Urban Design and Landscape Evidence

IN THE MATTER OF Plan Change 10 to the
Operative Selwyn District Plan

REPORT BY IAN CRAIG

HARRISON GRIERSON CONSULTANTS LIMITED

ATTACHMENT 4: Diagram Showing Intentions of Screening Regime

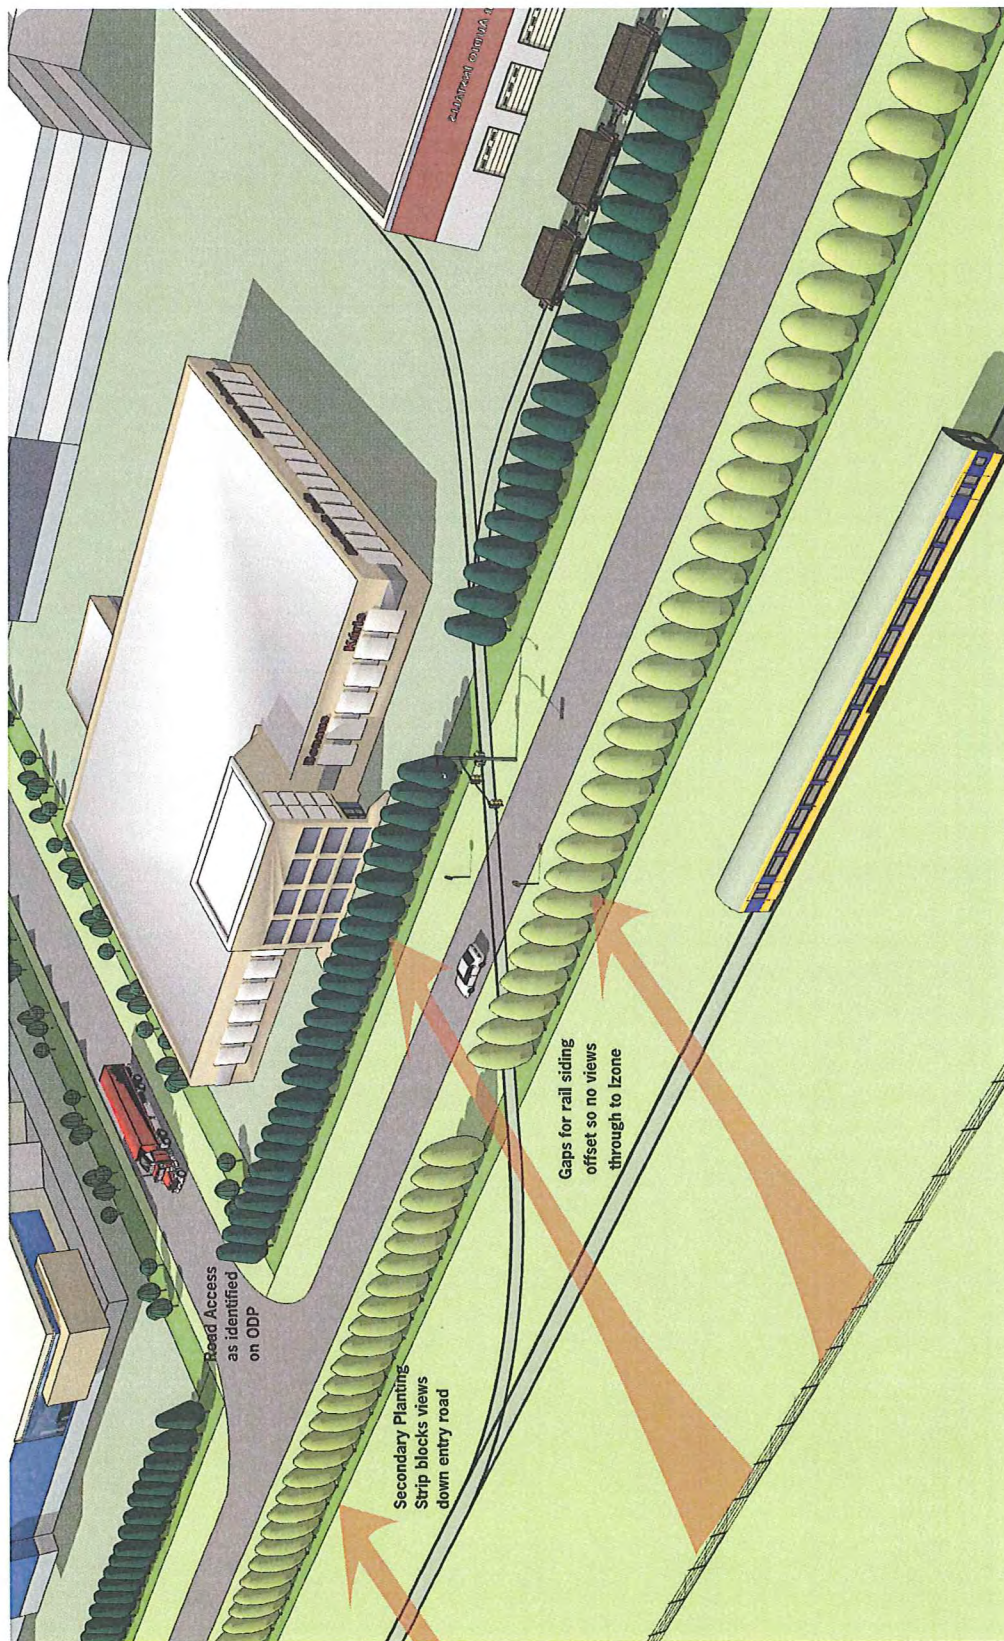
- 6.28 **Attachment Four** shows the intentions graphically. That is, the new hedgerow will block views from the southwest through the gap created by the road access, and that, because they will be offset, the gaps required for any rail sidings will not result in a "double gap".

- 6.31 However, in re-examining the Plan provisions, I have noted an anomaly I consider should be corrected in the light of the submitters' concerns, namely that the provisions associated with the "secondary planting strip" are silent on what to do about breaks in this new shelterbelt, once established, which might be required for rail crossings. While the secondary planting strip shall be maintained and replaced if dead, diseased or damaged, what happens if a gap is required to facilitate a rail siding?

- 6.32 My recommendation is to deal with this by modifying Rule 17.6.1 to apply to the secondary planting strip, once established – that is, it will become a restricted discretionary activity to create gaps in this planting strip as well. References in

*"The establishment of a road or rail crossing requiring a break in the existing primary shelterbelt **or future secondary planting strip** required by Landscape Treatment Three in Rule 24.1.3.13 along the Railway Road frontage of the Business 2A zone shall be restricted discretionary activity".*
